Access Compliance Report

Public Rights-of-Way

(Curb Ramps)

Intersection ID: N/A	Main Street: SOUTH_BV	Cross Street: N/A	Location: S
ADA ID: 0916F35BCCC9	Ramp Type: Directional1	Initial Pass/Fail: Fail	Overall Compliance: No
		Severity Score: 1.25

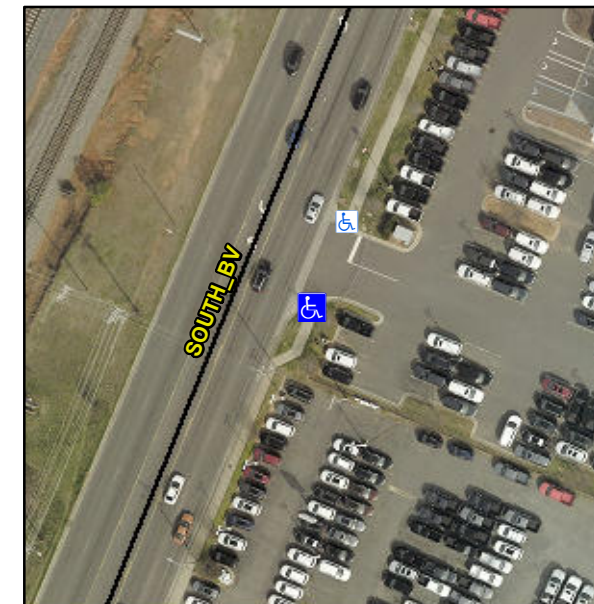
R304.5.3

Compliance	Description	Data	Compliance	Description	Data
N/A	Ramp Length (in)	59.0	N/A	Grade Break?	N/A
Yes	Ramp Width (in)	48.0	N/A	Grade Break Slope (%)	0.0
Yes	Ramp Slope (%)	3.4	N/A	Grade Break XSlope (%)	0.0
No	Ramp XSlope (%)	2.6			
N/A	Flare Type LT	N/A	N/A	Flare Type RT	N/A
N/A	Flare Slope LT (%)	N/A	N/A	Flare Slope RT (%)	0.0
N/A	Flare Traversable LT?	N/A	N/A	Flare Traversable RT?	N/A
N/A	Landing Length (in)	0.0	N/A	DWS Provided?	N/A
N/A	Landing Width (in)	0.0	N/A	DWS Contrast?	N/A
N/A	Landing Slope (%)	0.0	N/A	DWS Length (in)	N/A
N/A	Landing X Slope (%)	0.0	N/A	DWS Full Width?	N/A
N/A	Landing Curb? (Y/N)	N/A	N/A	DWS Offset LT (in)	N/A
N/A	Shared Landing?	N/A	N/A	DWS Offset RT (in)	N/A
N/A	Gutter Ponding?	0.0	N/A	Gutter Slope (%)	N/A
N/A	Gutter Lip Ht (in)	0.0	N/A	Gutter X Slope (%)	N/A
N/A	Painted X Walk1?	No		Road Slope (%)	4.3
	X Walk 1 Direction	To N		Road X Slope (%)	0.7
	X Walk 1 Width (in)	N/A		Clear Space?	N/A

Remove & Replace Entire Ramp.
